Subject: Revision to FSAR Submitted in April 2004.

Docket No. 50-184

13.2.2.2.2 Rapid Removal on an Experiment

Figure 1 - Transient power as calculated with MATLAB

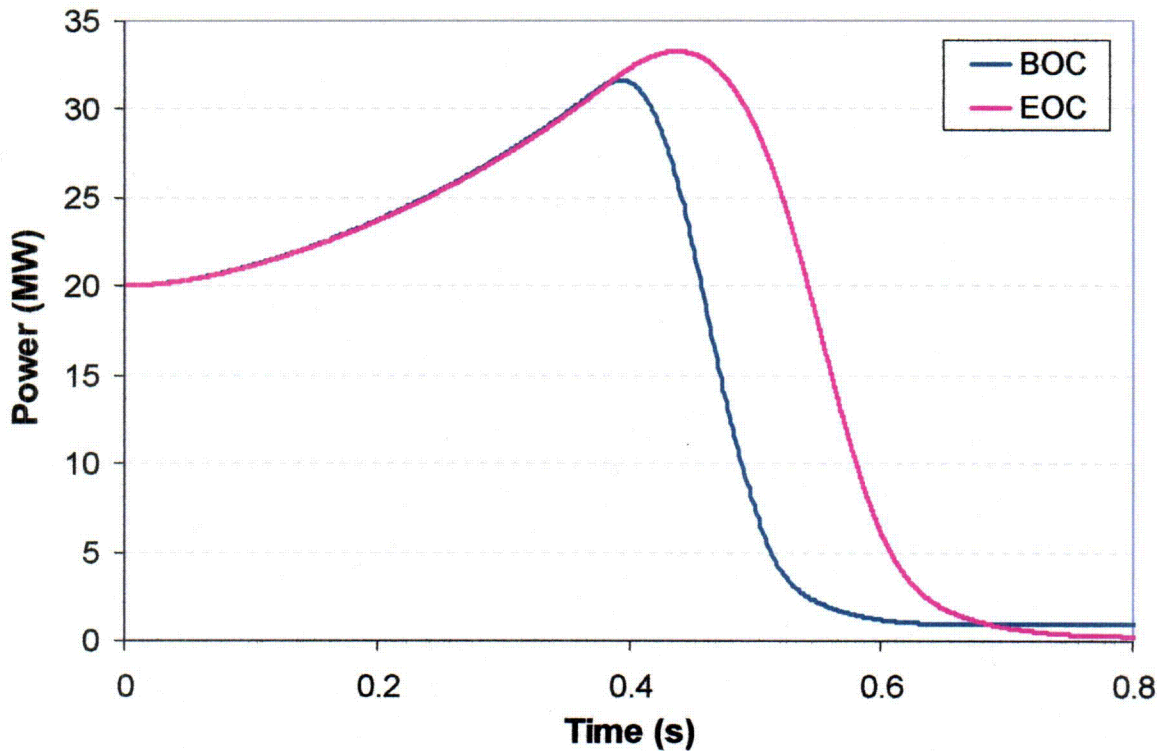
The transient reactor powers for beginning-of-cycle (BOC) and end-of-cycle (EOC) conditions are plotted in Figure 1.

In both cases, the power exceeds the reactor trip setpoint (130% or 26 MW) at 267 ms, and the shim arms start inserting into the core at 366 ms. At this point, since the initial shim arm positions are different for BOC and EOC, the BOC and EOC powers begin to differ. For BOC conditions, power reaches a peak of 31.6 MW at 392 ms, whereas for EOC the peak is delayed and somewhat higher, 33.3 MW at 437 ms. This results in total excursion energies above 20 MW of 2.20 MJ for BOC and 3.01 MJ for EOC.

Figure 2 - Shim arm reactivity vs. position

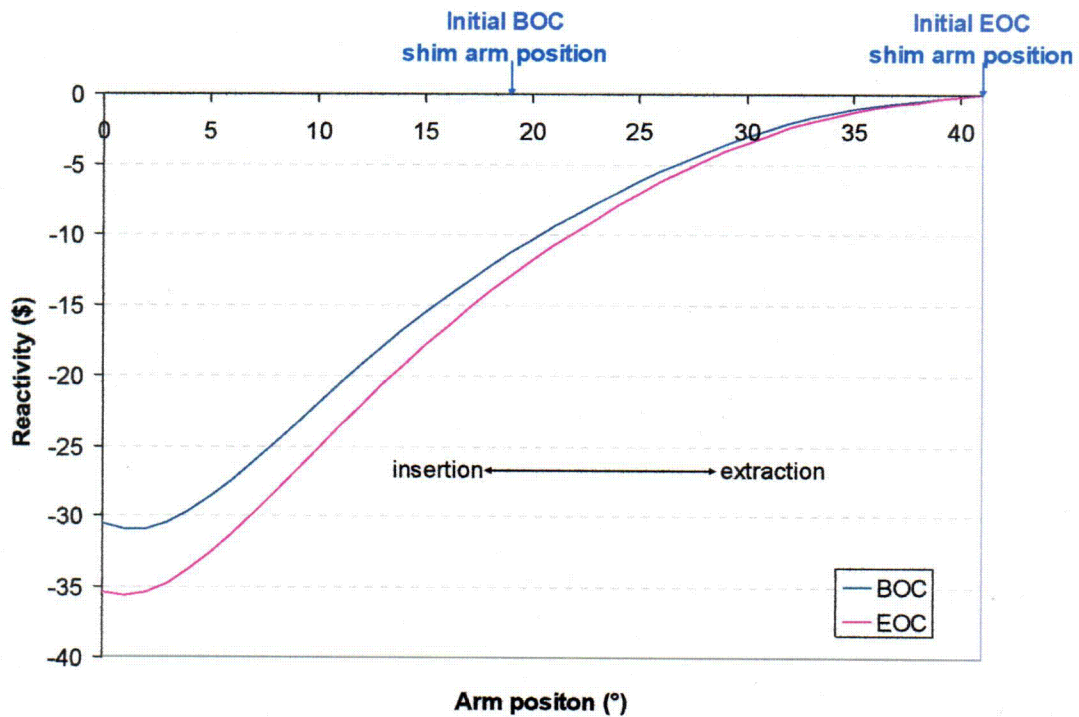
Figure 2 shows the shim arm reactivity for each initial condition. Note that for BOC the shim arms are initially partially inserted whereas they are completely withdrawn for EOC. Since the reactivity insertion rate is higher when the shim arms move from intermediate positions, the post-scrum reactivity decreases more rapidly for BOC, resulting, as previously shown, in an earlier and lower power peak.

Figure 3 – CHF inner and outer core

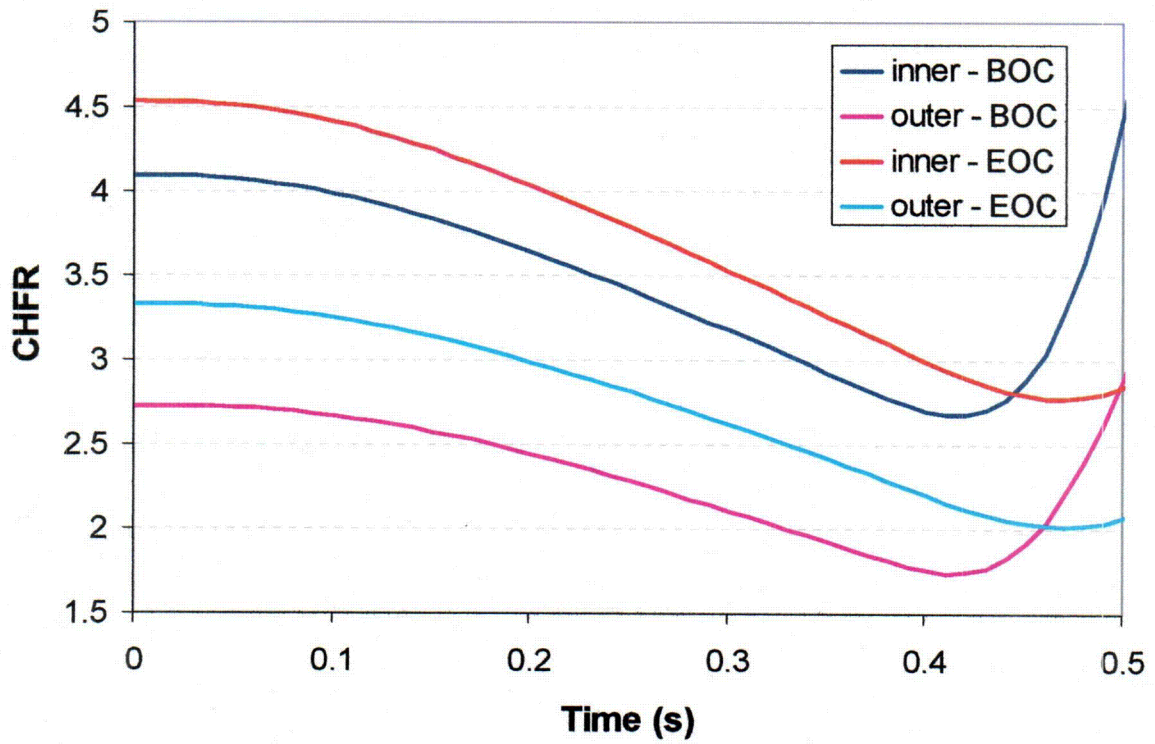
To ensure the fuel plates will not be damaged during the accident, the ratio of critical heat flux to local heat flux at their surface (CHFR) is monitored and shown in Figure 3 for the hottest node of the fuel plates both in the inner and the outer parts of the core. The minimum transient CHFR is 1.74 for BOC and 2.01 for EOC, well above 1.538, the value that corresponds to a 99.9% probability that there is no overheating in any subregion of the core. Table 1 summarizes of the main results presented in this report, and Tables 2 and 3 show detailed results for BOC and EOC respectively.
